Subject: AP1000 DCD Impact Document Submittal of APP-GW-GLE-009, Revision 0

APP-GW-GLE-009

“Alternate Steam and Power Conversion Design”

Title: Alternate Steam and Power Conversion Design

Figure 2.2.4-1 (Sheet 3 of 3)
 Steam Generator System

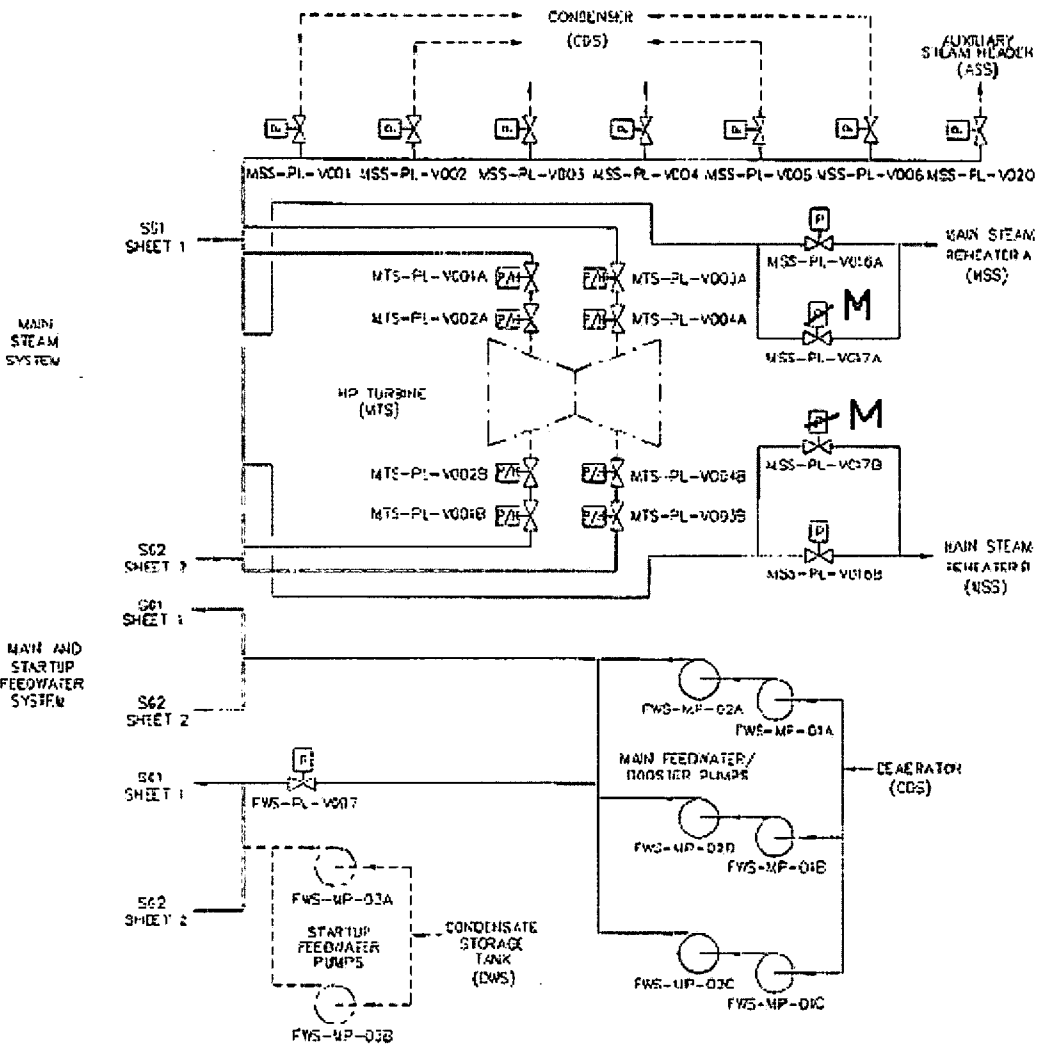
This DCD Impact document identifies an impact to a Tier 1 Figure in the Rev 16 DCD. A mark-up of the affected figure is included on page 5 of this document.

This DCD impact document does not require any changes to the design itself. It identifies an impacted figure that should have been included in previous changes to the DCD. The figure was Tier 1, Figure 2.2.4-1 that should have been changed in TR 86.

In Tier 1 Figure 2.2.4-1 (Sheet 3 of 3) two valve symbols marked with a "P" representing pneumatic actuators should have been corrected with the letter "M" indicating motor operated valves to be consistent with the change to Tier 2 Figure 10.3.2-2. Since this change was not identified in TR 86, it is being identified now in this DCD Impact document.

Changes are shown with deletions shown with strikeout and additions underlined. Additions and changes shown previously in other submittals are shown in italics.
